MEMORANDUM

Subject: Austin Barefoot Ski Club (ABSC) barefoot jump ramp

Subject: Construction of Thomas Boat dock at 2315 Island Wood Road
File No. SP-98-0407DS

Subject: Construction of Grotto Boat dock at 4303 Island Avenue.
File No. SP-98-0393DS.

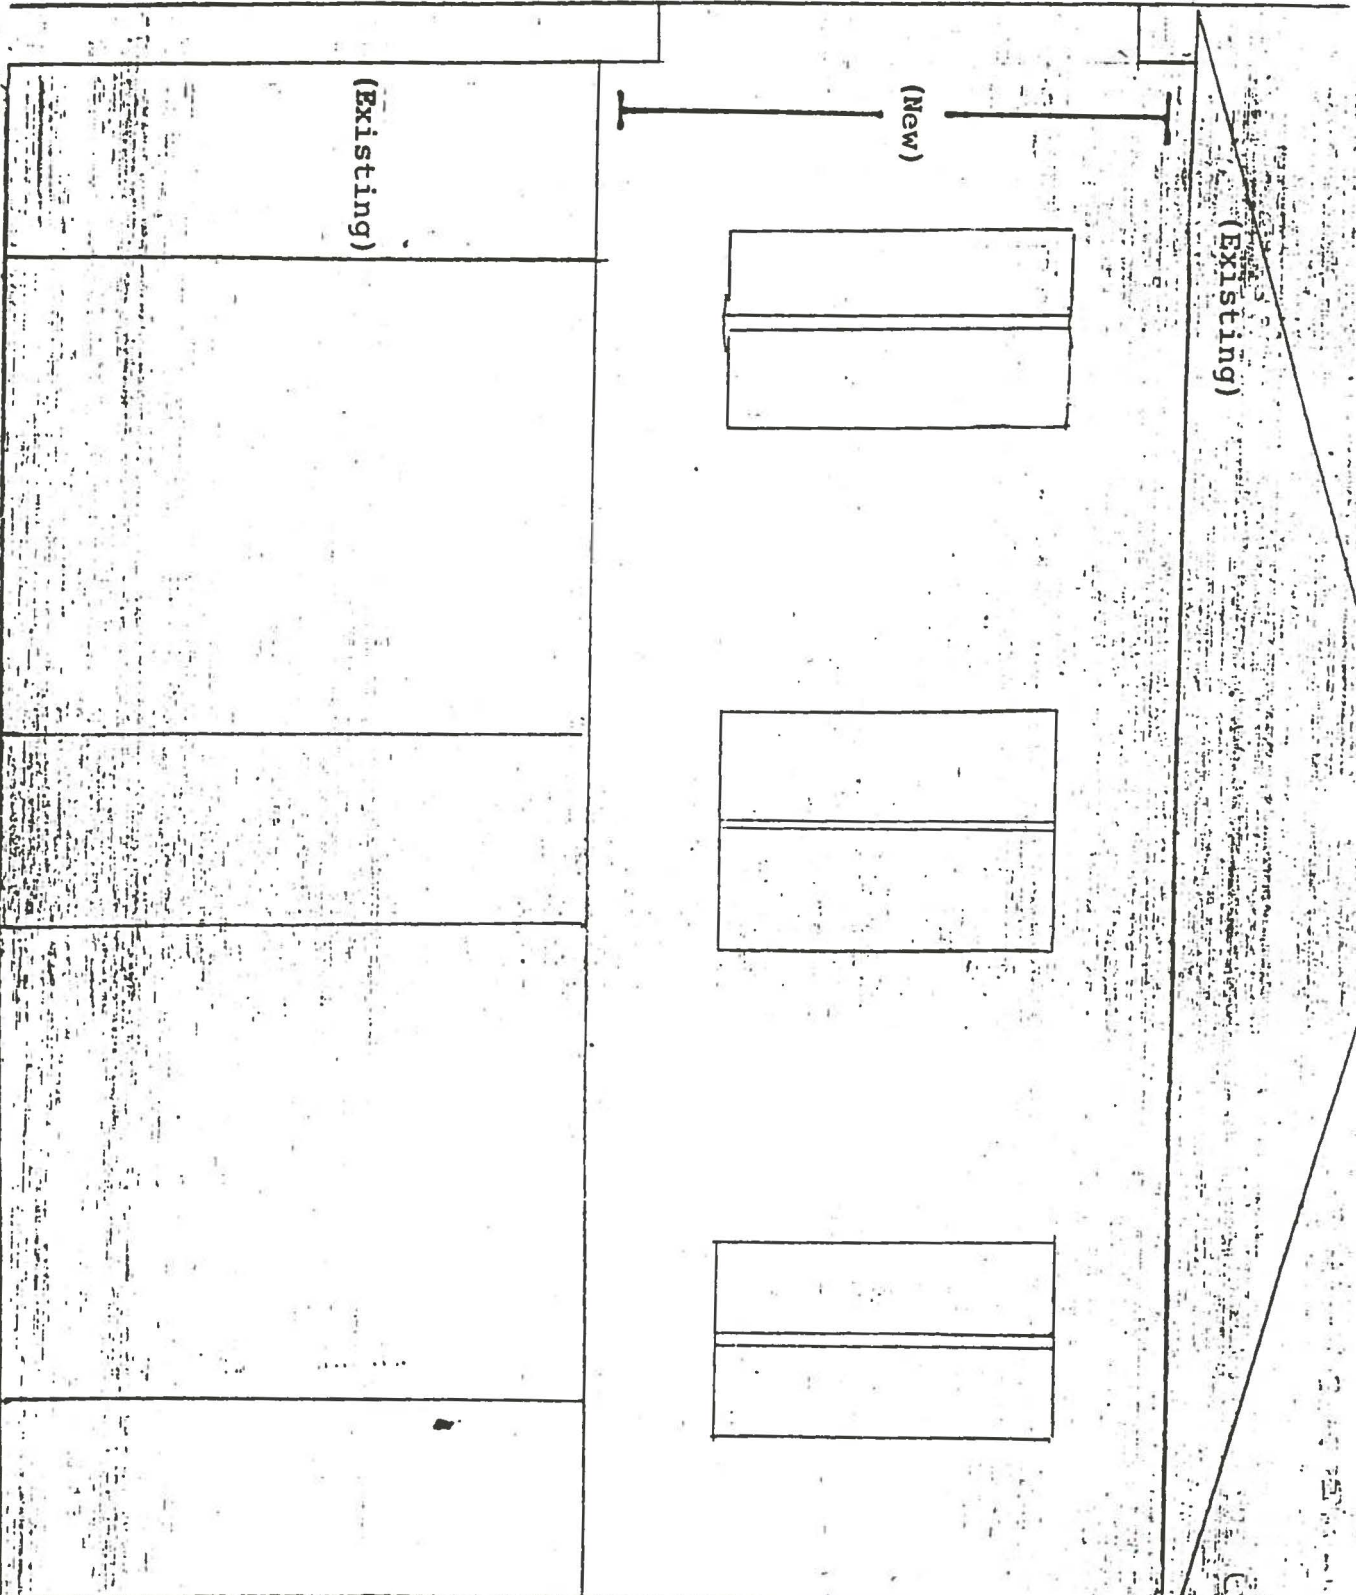
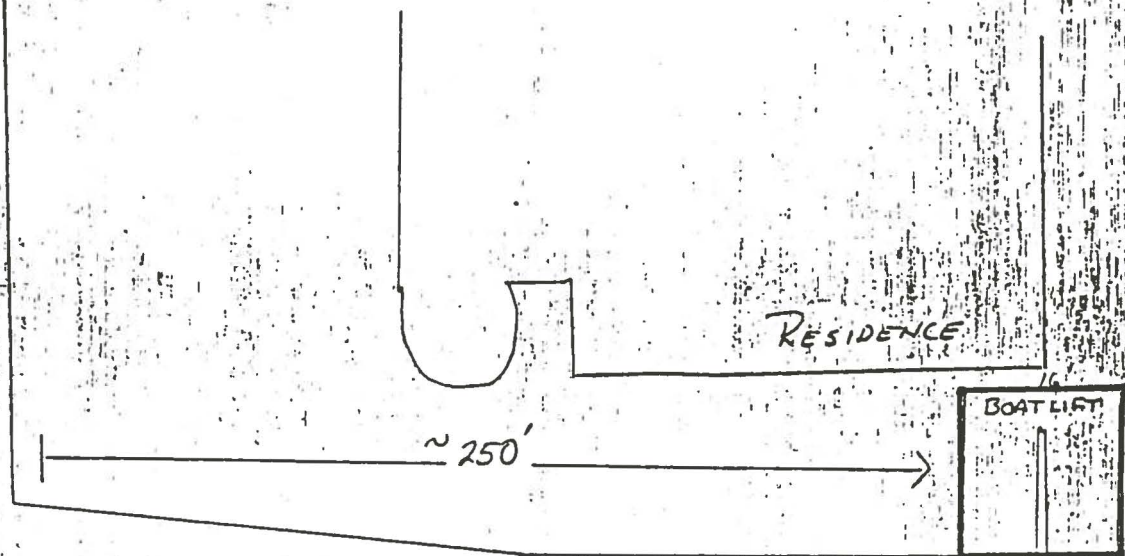
The Parks and Recreation Department (PARD) staff has reviewed plans for the proposed project and finds they do not meet the requirements of Article VI, Part E, (Requirements for the Construction of Boat Docks) of the Land Development Code. We believe that allowing living quarters to be erected above water on Lake Austin would set a precedence that would degrade the scenic and recreational values of the lake.

I do not recommend the approval of the above request as detailed in the attached site plan.
